HOUSE OF REPRESENTATIVES

(REPORT BY MR. J. O'DEA UPON THE VENTILATION OF THE).

Mr. J. O'DEA to the Hon. the MINISTER for PUBLIC WORKS.

Combination Ventilating Cowl

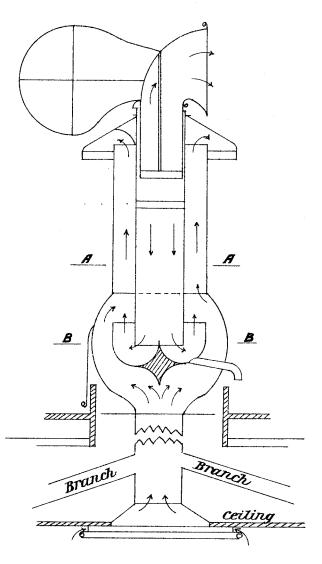
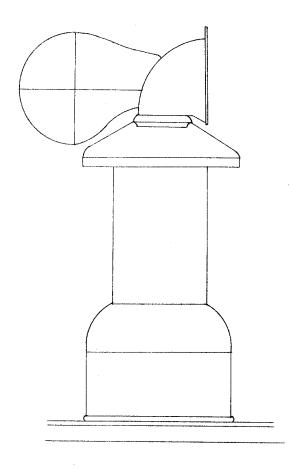
2. The ventilation on the roofs and ceilings is by no means sufficient to pump out the air from within the House, and as a consequence it must escape through doorways when others are opened in opposite directions: this of course causes draughts, and can be remedied only by sufficient ventilation in the roofs and ceilings without causing a down-current. I enclose plan of ventilator which I would recommend to be fixed on the roofs and ceilings in place of those already on, which are quite useless, as they had to be closed on account of the down-draught which they cause. This ventilator which I recommend is constructed on the siphon principle, and is superior to any of the latest improvements, and moreover I would be pleased to make a practical test for you when convenient, as I have had a model made specially for that purpose. I would recommend two of this plan to be fixed on the roof over chamber, six in the lobbies to the right of the chamber leading to the galleries, and two with branches over the strangers' gallery, and landing outside the reporters' gallery.
